APPROVED MINUTES

September 20, 2012 Standards Committee Meeting

RE: Minutes from the September 20, 2012 Standards Committee Meeting

REVISED STANDARD DRAWING 805-SGSP-04 BASE PLATE FOR SIGNAL STEEL STRAIN POLE (DRAFT)

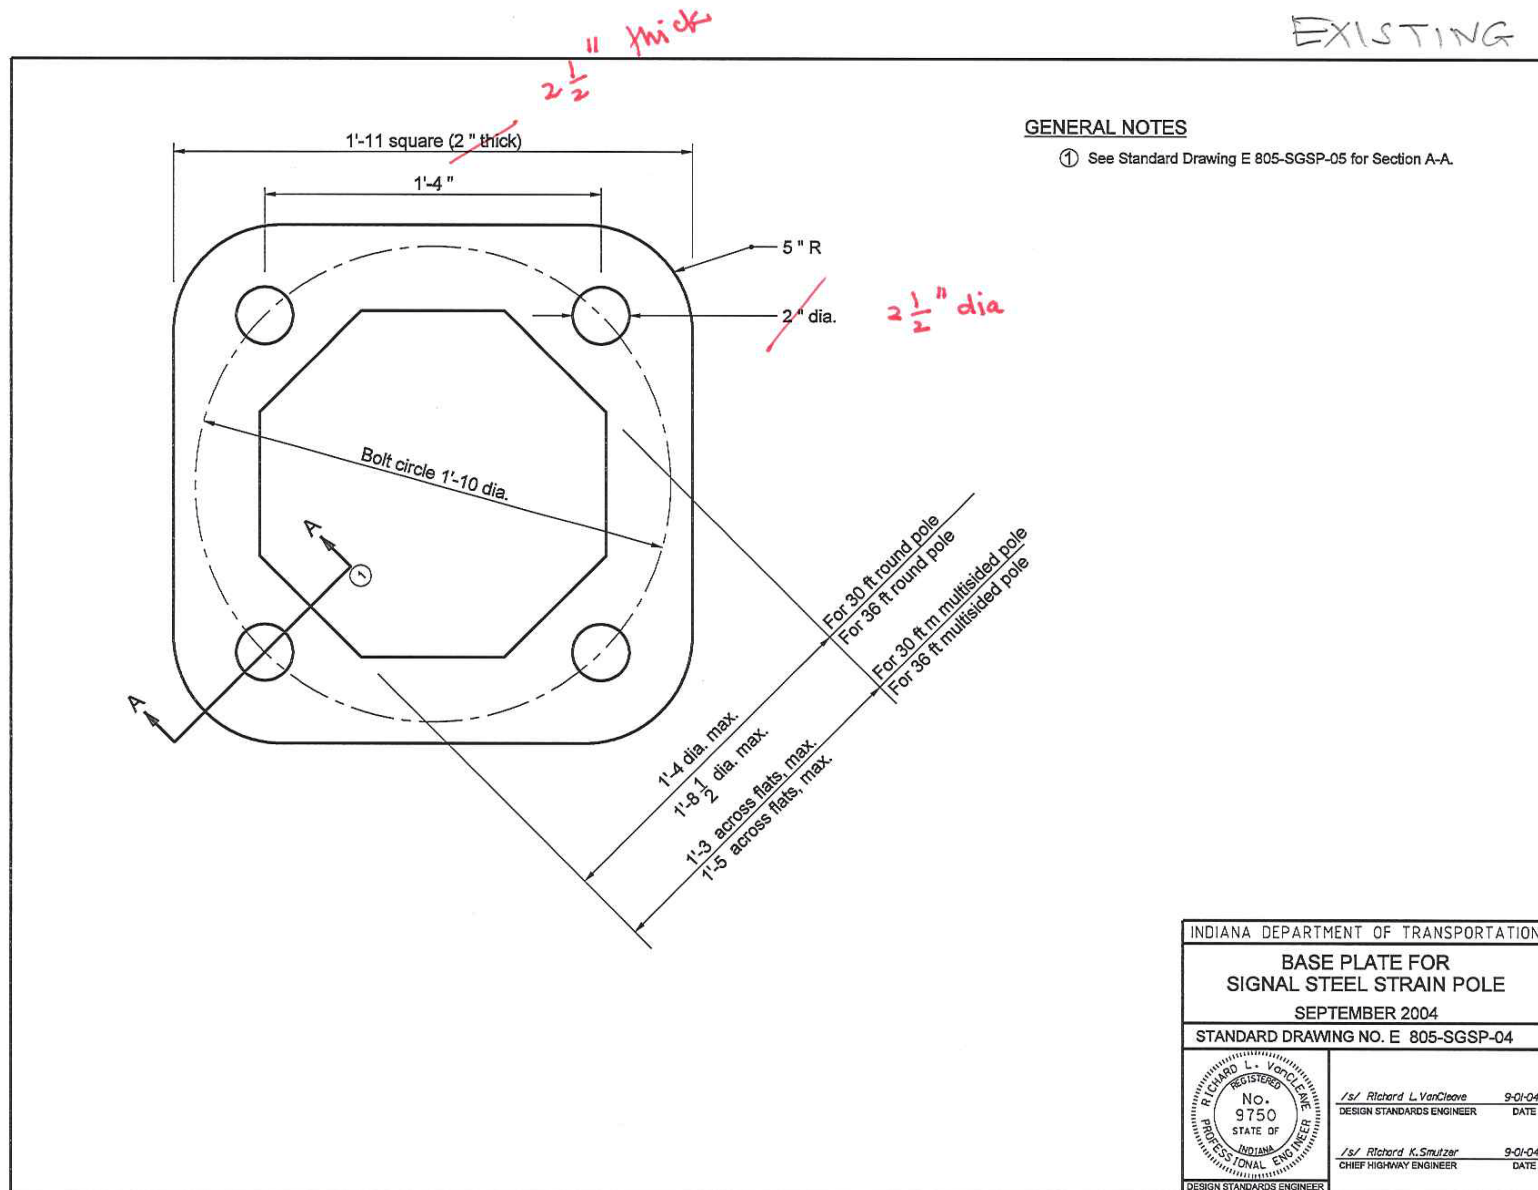
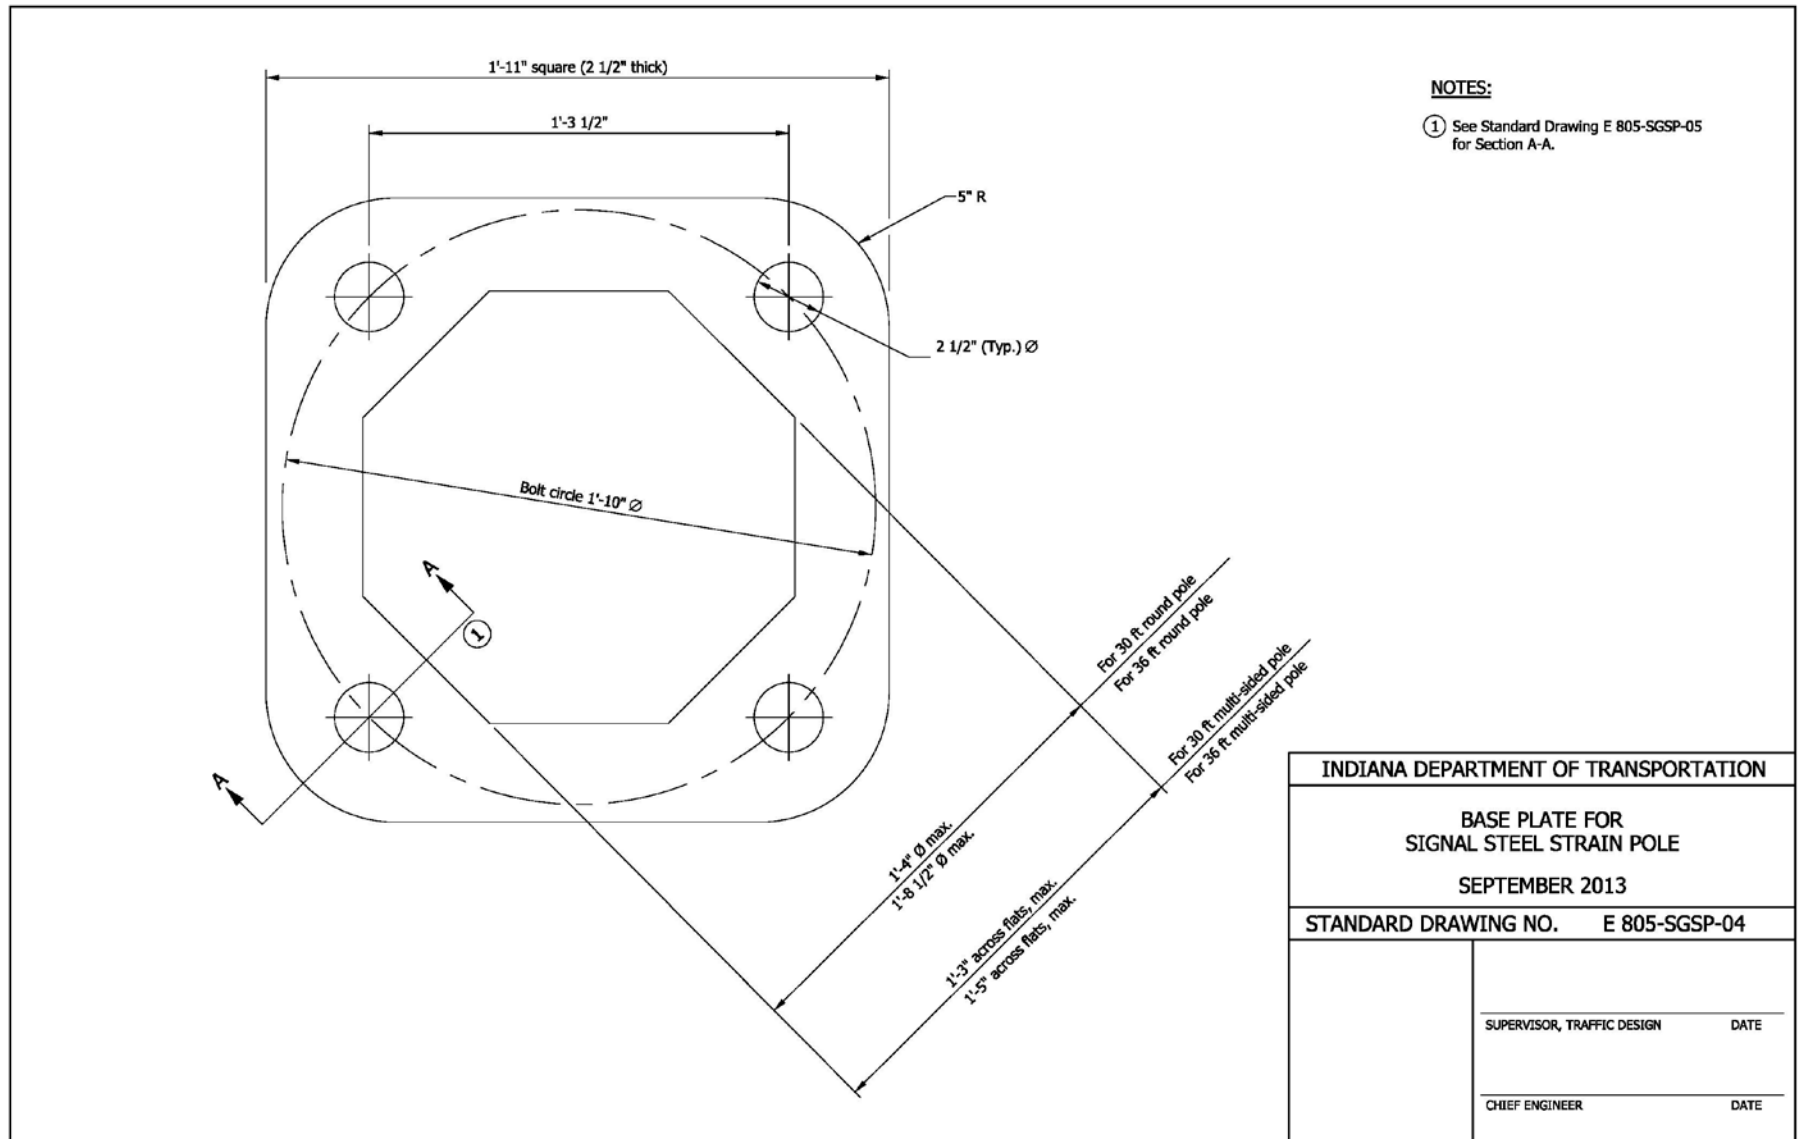
1. On panel sign assemblies the distance between the bottom of the panel sign and the top of the fuse plate often varies from one post to the other in the same assembly. This may lead to the breakaway mechanism not functioning correctly.
2. Clips that attach the sign panel to the support I-beams are not being installed on both sides of the I-beam for signs wider than 24' as they should be. This makes it more likely that the sign will separate from the supports.
3. Standard Drawing 805-SGSP-04 for signal strain poles contains incorrect dimensions for the base plate thickness and anchor bolt hole diameter.

Mr. Boruff continued explaining the rest of the revisions presented. Ms. Phillips asked about the bolt circle and Mr. Boruff stated that it is correct and that it is centered.

1. Add a note to Standard drawing 802-SNGP-01 that "The distance from top of the fuse plate to the bottom of the sign shall be the same for all posts"
2. Revise Standard drawing 802-SNGP-03 to indicate that clips on both the left side and right side of the posts are required for signs wider than 24'.
3. Revise Standard drawing 805-SGSP-04 by correcting the anchor bolt hole diameter to 2 1/2" (currently shown as 2") and the base plate thickness to 2 1/2" (also currently shown as 2").

EXISTING 706-TTFC-01 CONCRETE BRIDGE RAILING TRANSITION TFC PLAN AND ELEVATION (WITH MARKUPS)

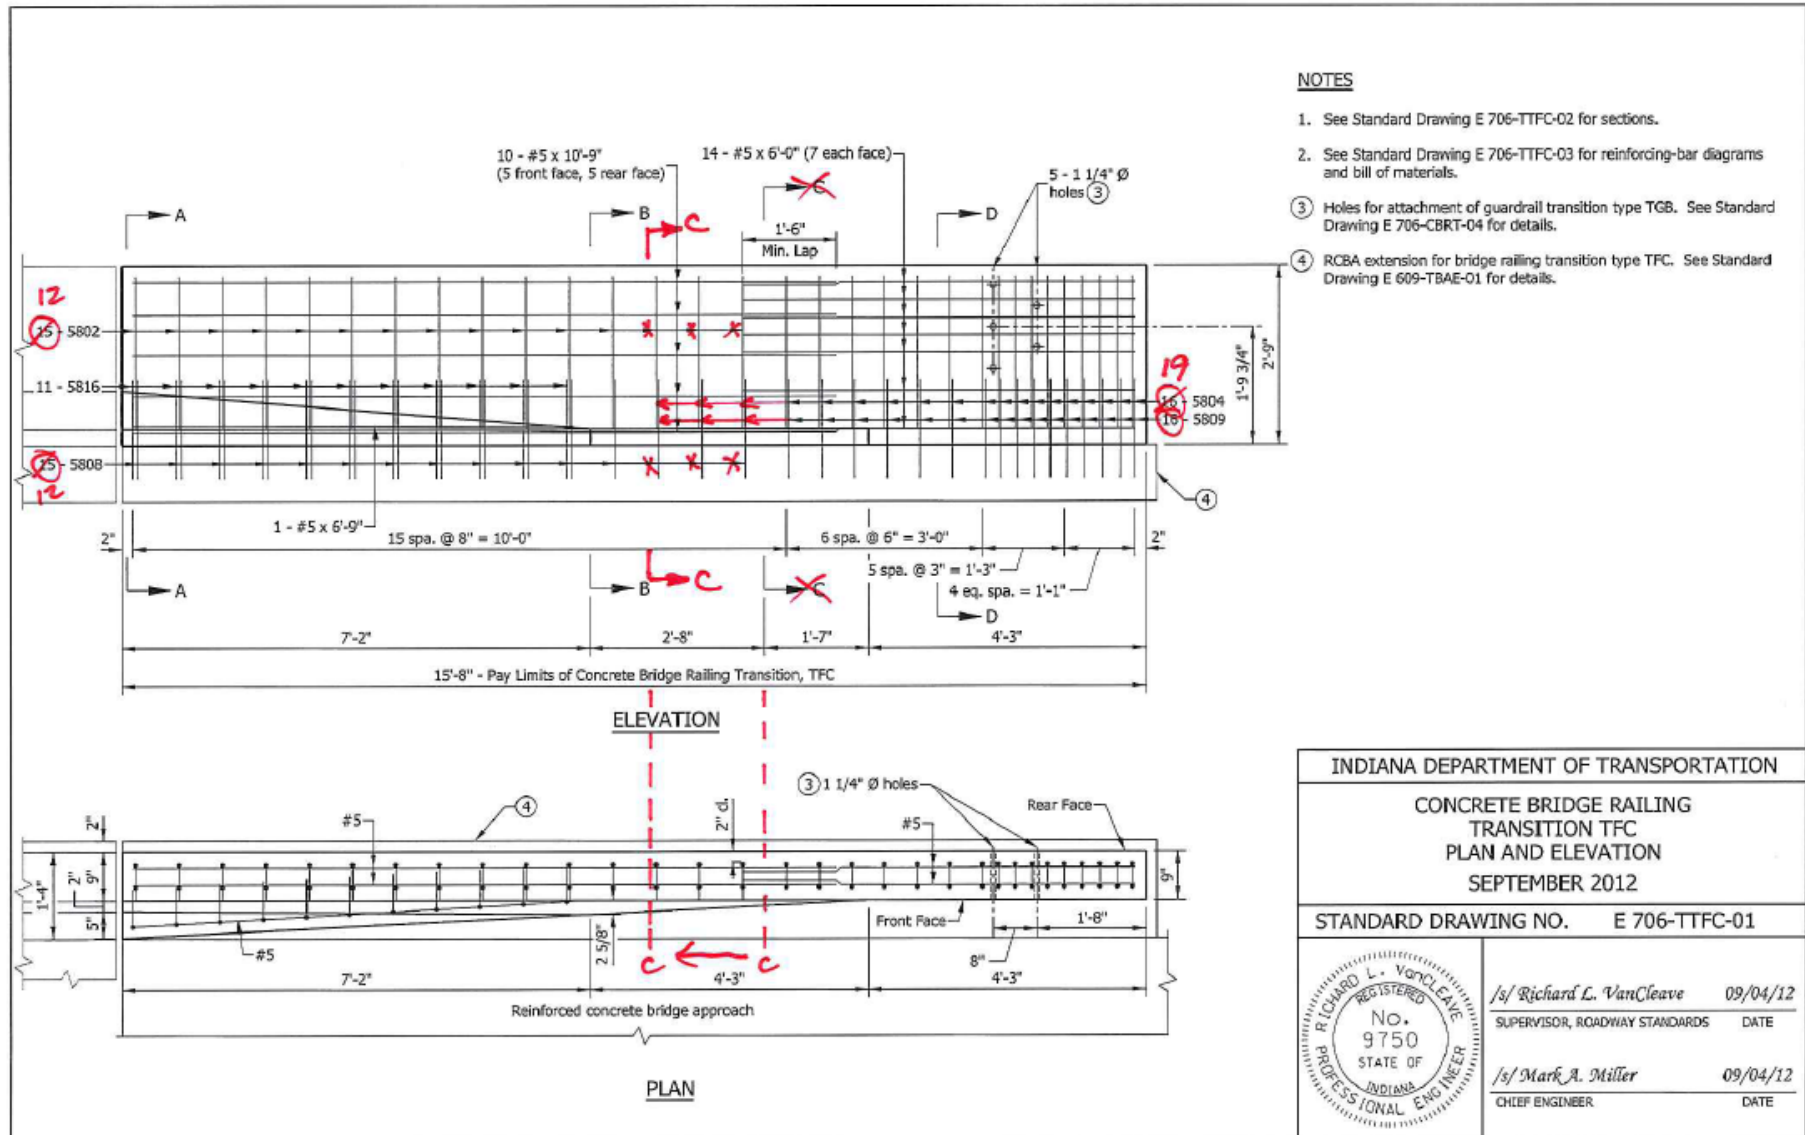
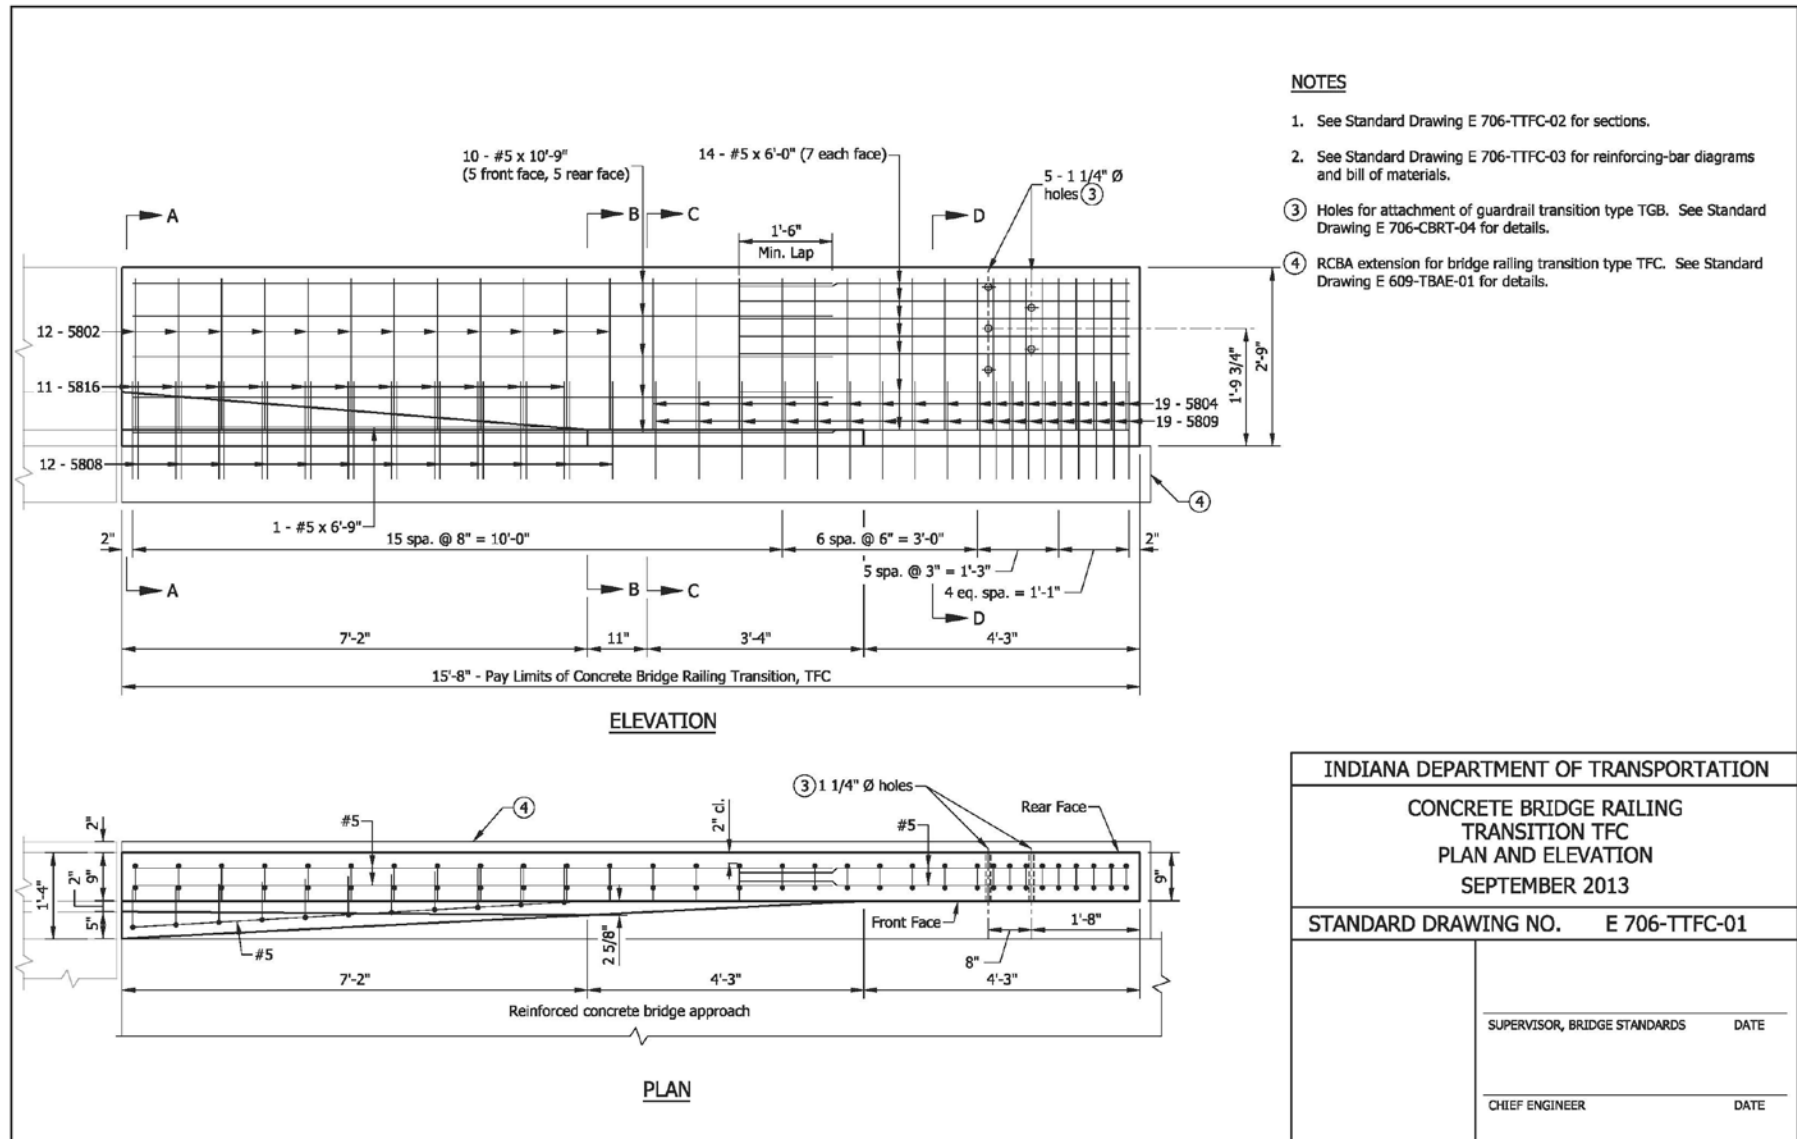
PROBLEM(S) ENCOUNTERED: A review of Standard Drawing 706-TTFC-01 through -03 revealed an error in the location of a section and consequently, an incorrect bill of materials.

PROPOSED SOLUTION: Revise the drawings to show the correct location of the section and quantities in the bill of materials. See attached markups and final drafts of proposed revised drawings.

EXISTING 706-TTFC-02 CONCRETE BRIDGE RAILING TRANSITION, TFC SECTIONS (WITH MARKUPS)

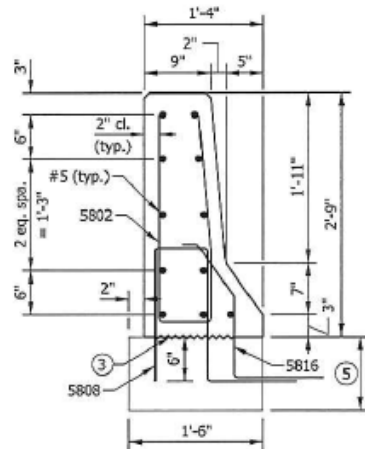
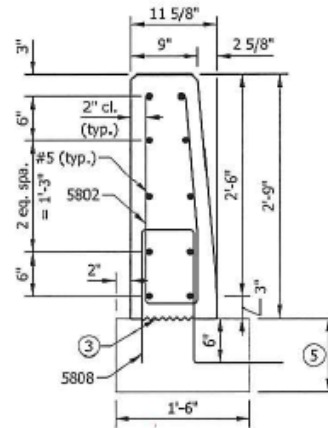
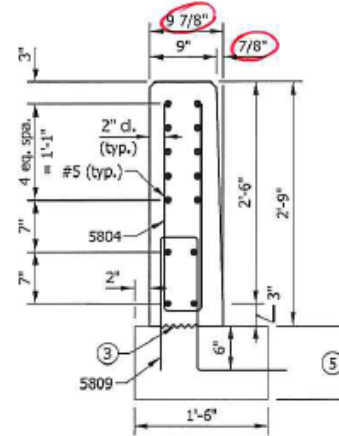
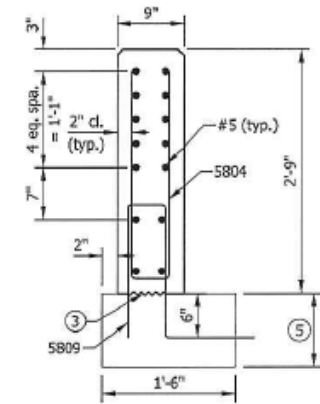
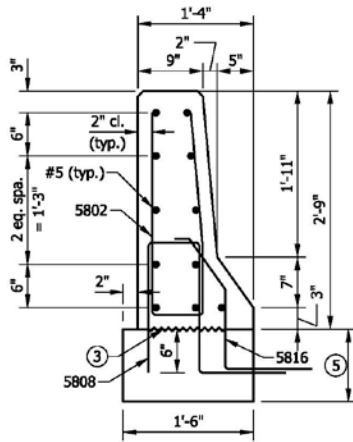
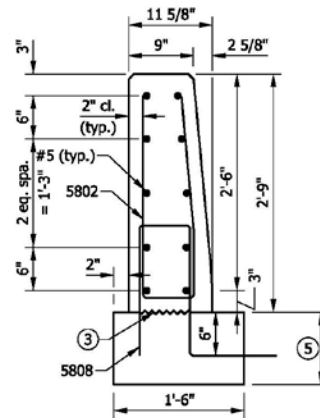
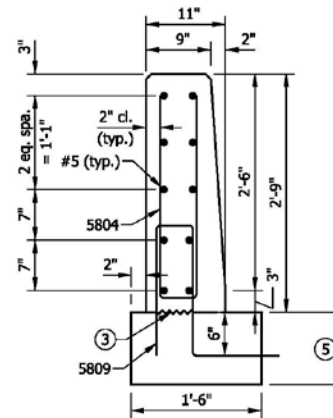
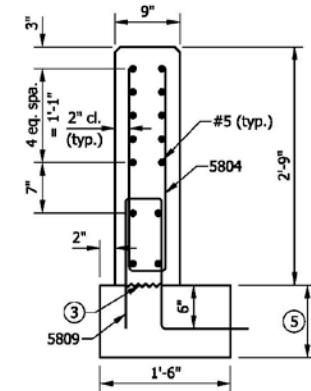
DISCUSSION: Ms. Phillips presented this item as shown and as described in the proposal page, and made a motion that this item be approved as submitted. Mr. Cales seconded that motion. Ms. Phillips then explained the revisions as shown attached above, and how the bill of materials is affected. A minor revision was recommended for section C-C, that the longitudinal bars should not be shown. Ms. Phillips will have that corrected.
